SHEET NAME:	BRIDGE 52 STREAM DIVERSION PLAN
PROJECT NAME:	WINHALL
PROJECT NO:	STP CULV (31)
DRAWN BY: CE	CHK'D BY:
DATE:	04/21/2015
SHEET NO.	1 OF 4

From: McIntosh, Mindon (Buffalo) [mindon.mcintosh@aecom.com]
Sent: Monday-May 04-2015 3-36 PM
To: cezequelle@gmail.com; renaudbr@sover.net
Cc: ron.lemaire@state.vt.us; acentofranchi@eivtech.com
Subject: FW: Winhall STP CULV(31) Water Diversion Plan Submittal

From: Jacqueline Dagesse [mailto:jdagesse@eivtech.com]
Sent: Wednesday, April 29, 2015 7:20 PM
To: Lemaire, Ron
Cc: Farley, William; Mackintosh, Mark
Subject: Winhall STP CULV(31) Water Diversion Plan Submittal

BRIDGE 52 STREAM DIVERSION PLAN
SCALE 1" = 20'-0"

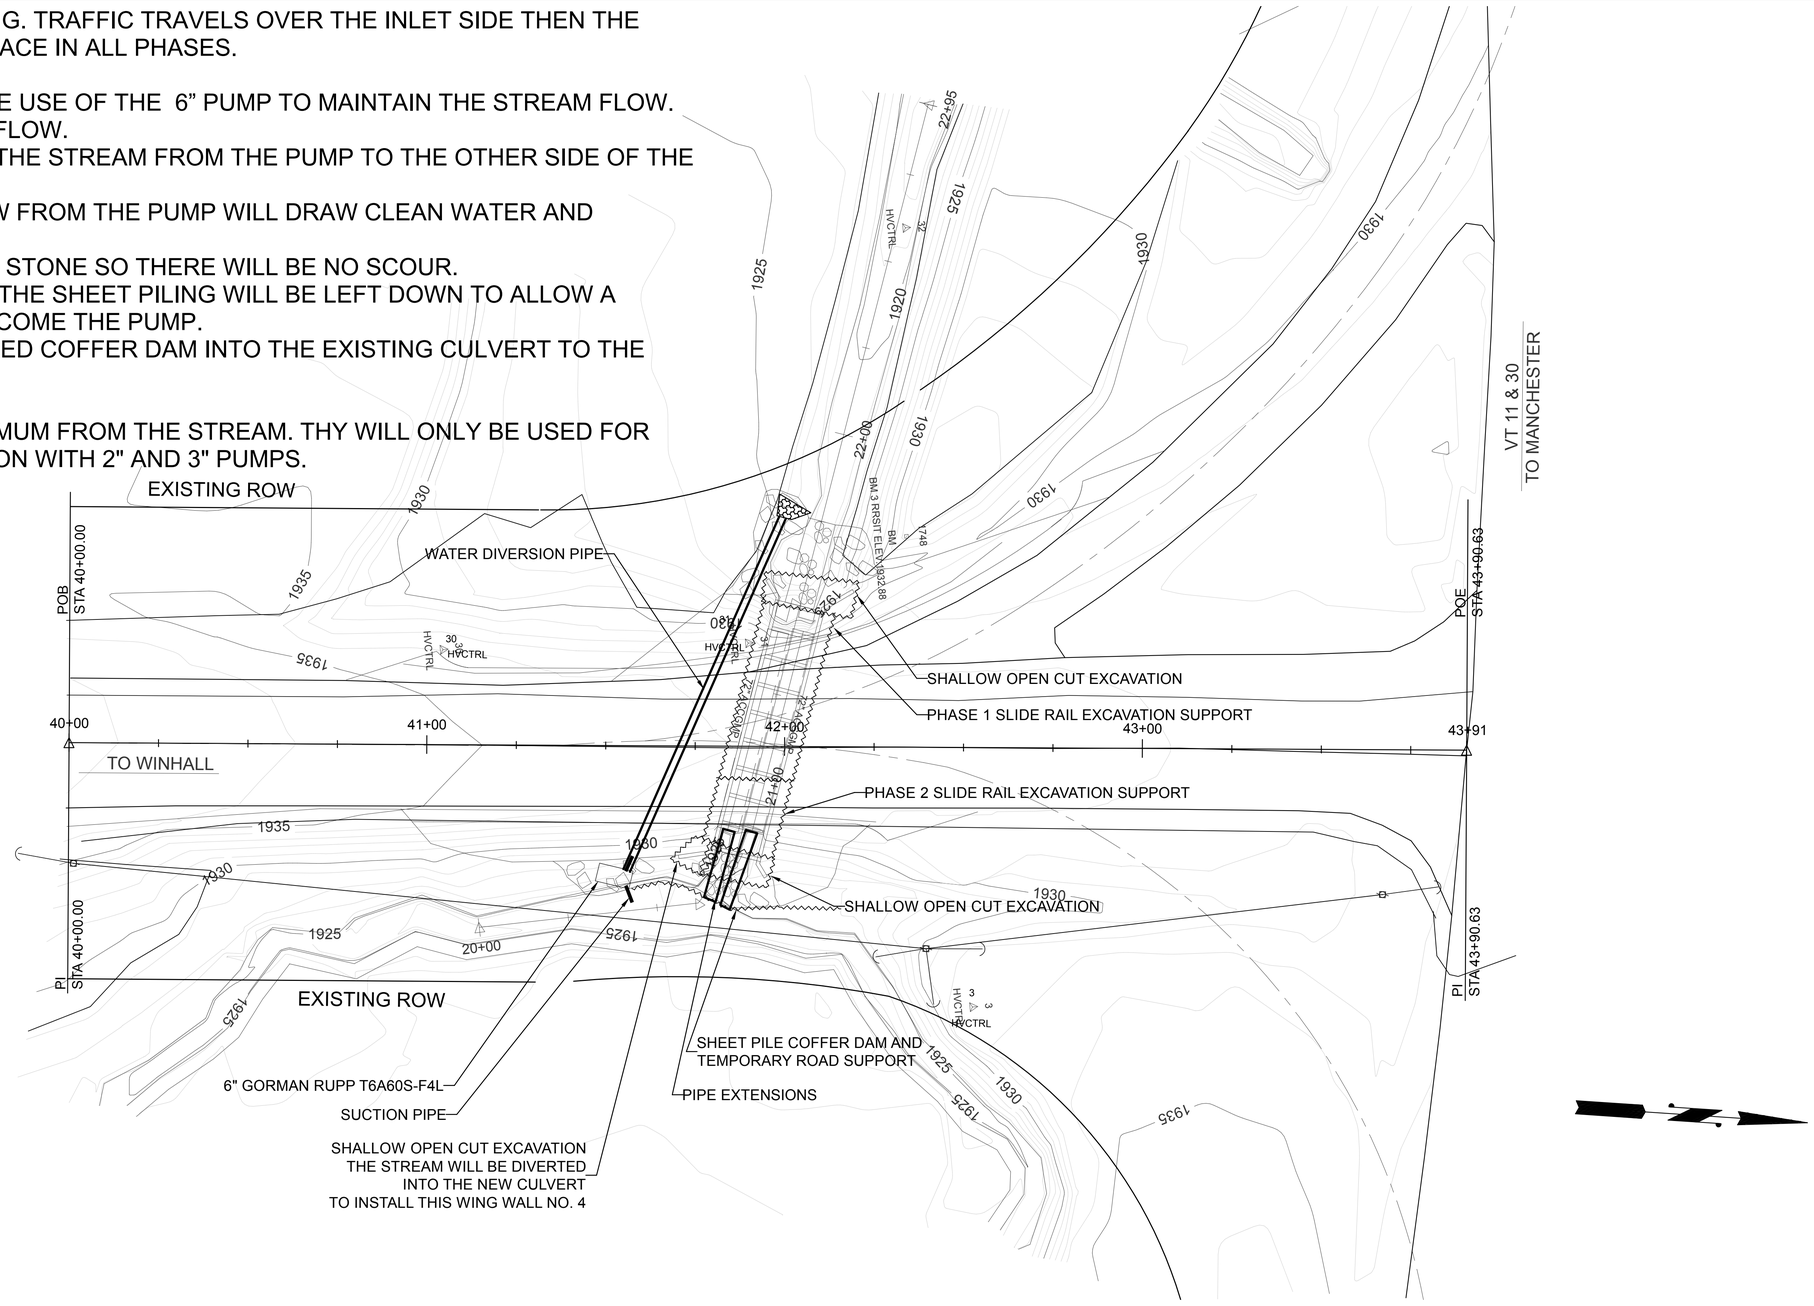
- Renaud Brothers mentions using a 6" pump for dewatering. What size event would this pump be able to handle?
- Where are they dewatering to? Using a filter bag? What is the backup plan?
- The plansheets that they provide need to have resource information, stationing and north arrow.
- We need a more detailed description of what they plan to do.

SEE THE STREAM DIVERSION PLAN FOR THE USE OF THE 6" PUMP TO MAINTAIN THE STREAM FLOW.
THE 6" PUMP WILL HANDLE THE 25cfs OHW FLOW.
THE PIPE LAID ACROSS THE ROAD CARIES THE STREAM FROM THE PUMP TO THE OTHER SIDE OF THE ROAD.
BY BUILDING AN ADAQUATE POND TO DRAW FROM THE PUMP WILL DRAW CLEAN WATER AND DISCHARGE CLEAN WATER.
THE CLEAN WATER WILL DISCHARGE ONTO STONE SO THERE WILL BE NO SCOUR.
AT THE INLET OF THE EXISTING CULVERTS THE SHEET PILING WILL BE LEFT DOWN TO ALLOW A RELIEF FOR THE STREAM SHOULD IT OVERCOME THE PUMP.
THE STREAM WILL FLOW OVER THE LOWERED COFFER DAM INTO THE EXISTING CULVERT TO THE NEW CULVERT AND BACK TO THE STREAM.

THE FILTER BAGS WILL BE PLACED 50' MINIMUM FROM THE STREAM. THY WILL ONLY BE USED FOR LOCALIZED PUMPING FROM THE EXCAVATION WITH 2" AND 3" PUMPS.
